PLANS AND DOCUMENTS
referred to in the PDA
DEVELOPMENT APPROVAL

Approval no: DEV2017/901
Date: 20 August 2019

Teviot Road, Jimboomba

Plan of Development
Stage 1A

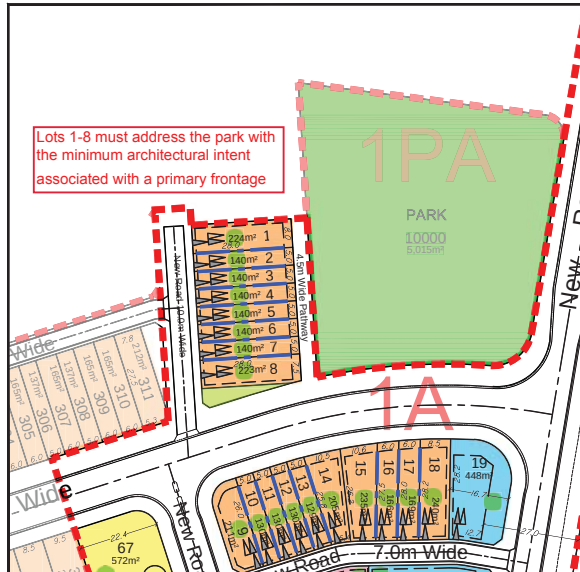
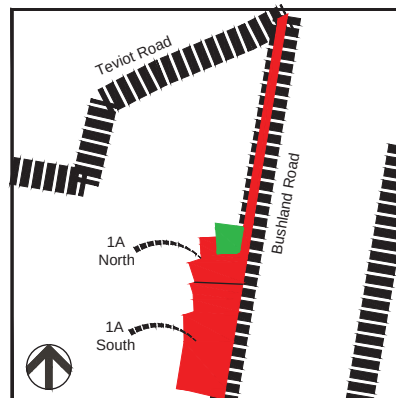
Lots 19-43 have a minimum setback of 5.75m to road boundary to accommodate required BAL29 conditions.

AMENDED IN RED
